TITLE: ElektroClub2022		REV: 1.0
EasyEDA	Company: Hobby	Sheet: 1/1
	Date: 2022-01-18 Drawn By: Maarten Pennings

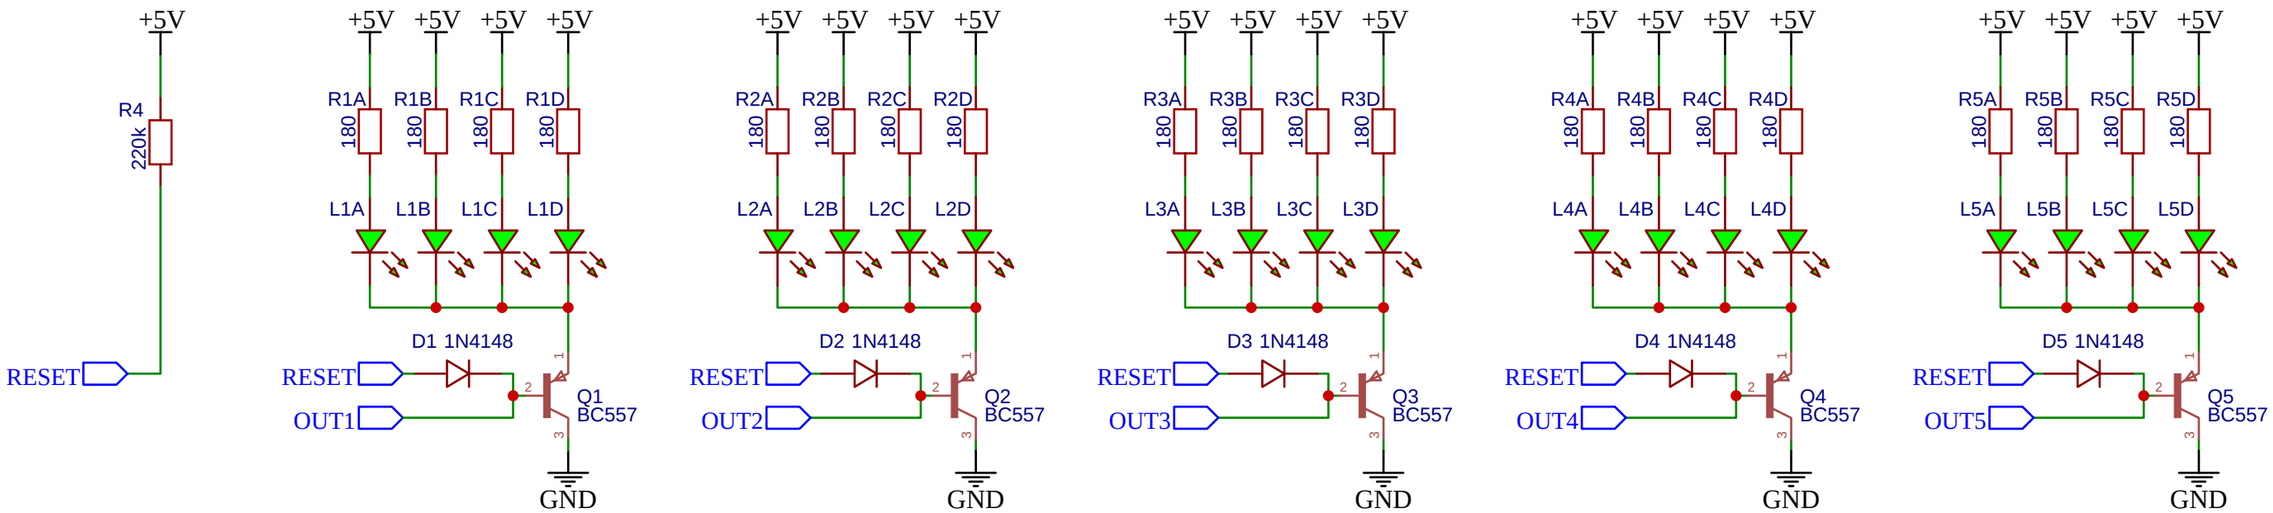
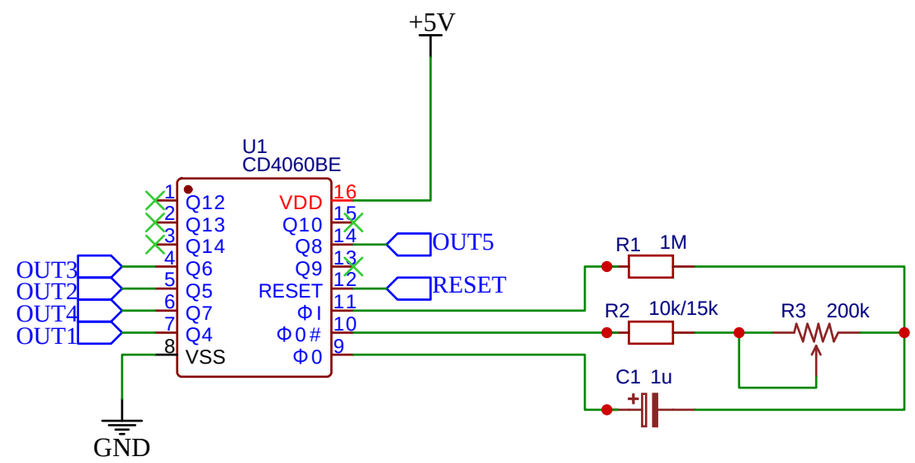
Could you review the clock circuit, the pin names are a bit funny.

Do we need to add a cap close to U1?

Do we need to add a cap over the power source?

Source schematic uses output 2,3,4 (Q5,Q6,Q7) of U1.
Why is output 1 (Q4) skipped (frequency related)?
We have five outputs not three, which do we add?
This schema has 1 and 5 (Q4 and Q8)
or do we want 5 and 6 (Q8 and Q9)?
